ADDENDUM

Project Name: Utility Tunnel Extension

Addendum No.: Two (2)

Project Designation: SUU University Cedar City, Utah

TUNNEL SECTION FILL REQUIREMENTS

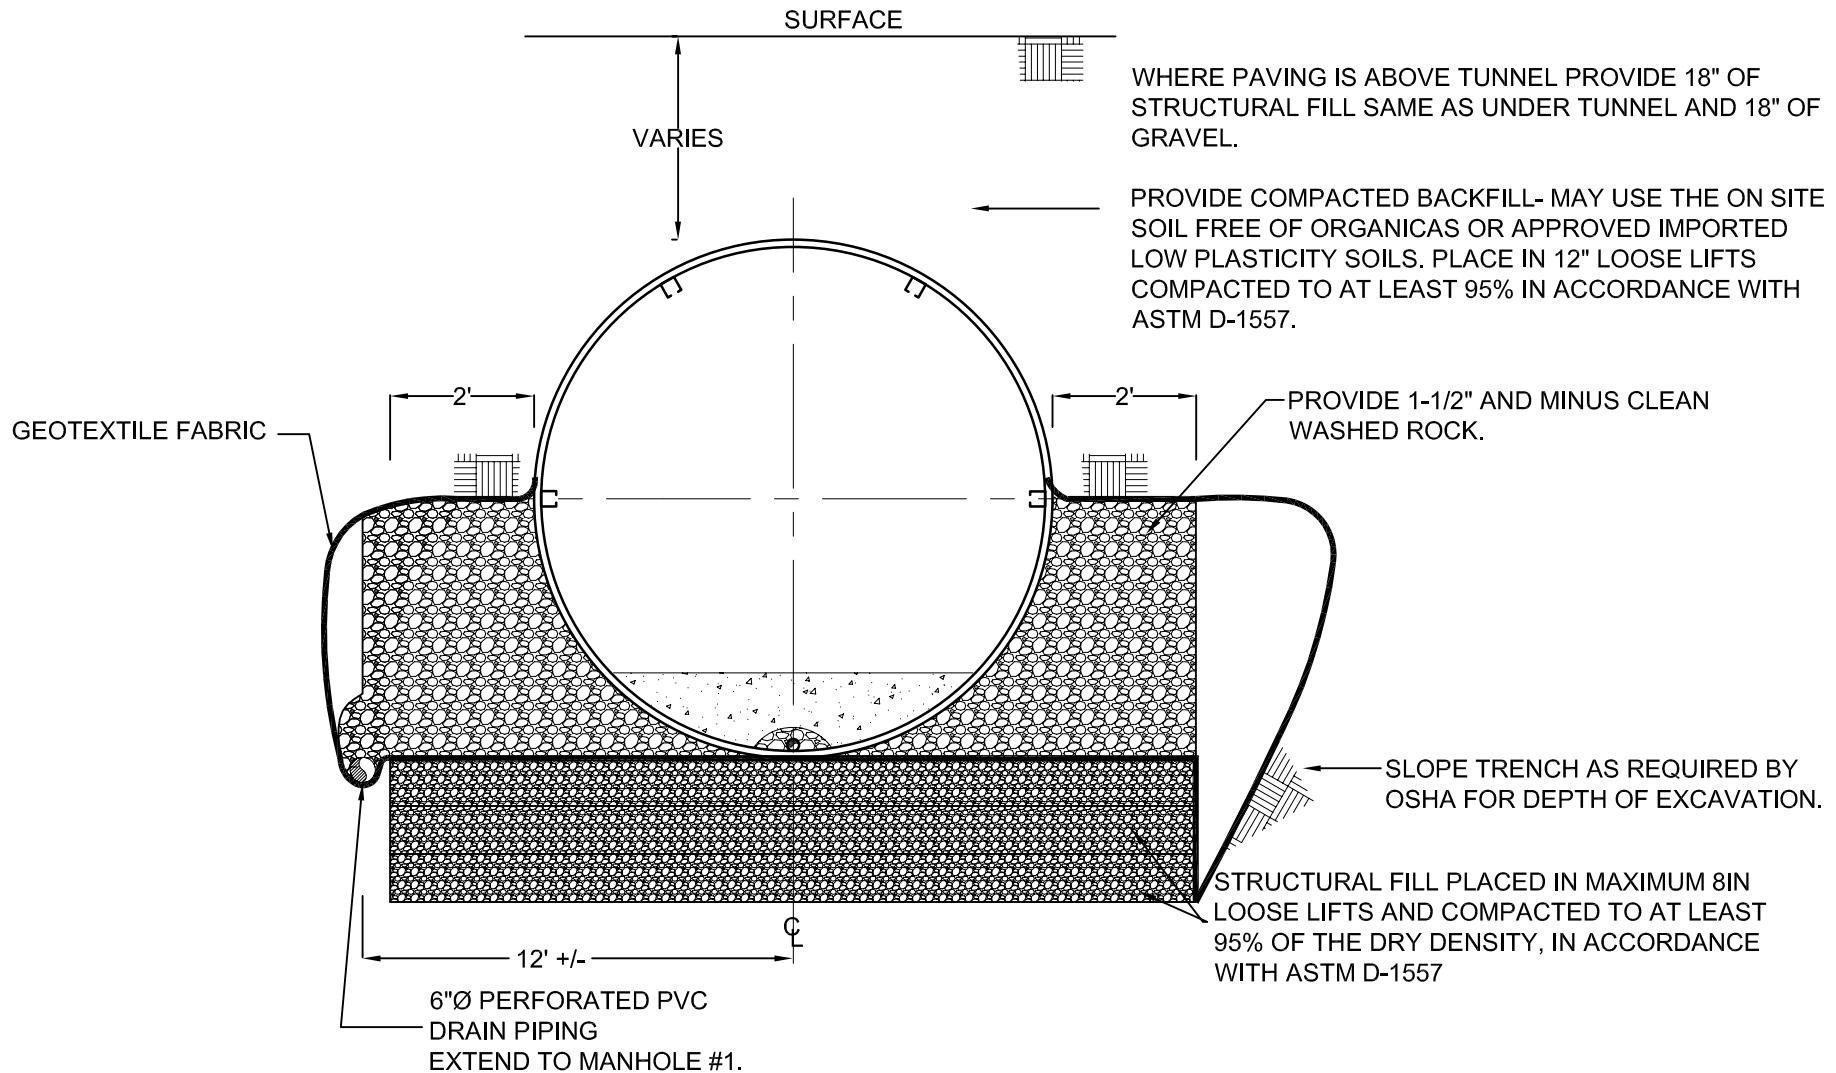
Item VI-1. Drawing D1/ME503 from Addendum #1 shall be changed as shown on the attached drawing D1/ME503. The drawing was changed to change the routing of the geotextile fabric and the pit run gravel to 1 ½" diam. and minus clean rock. See also the addition of the words "and 18" of gravel to top note. See also the new location of the 6" diam. drain pipe.
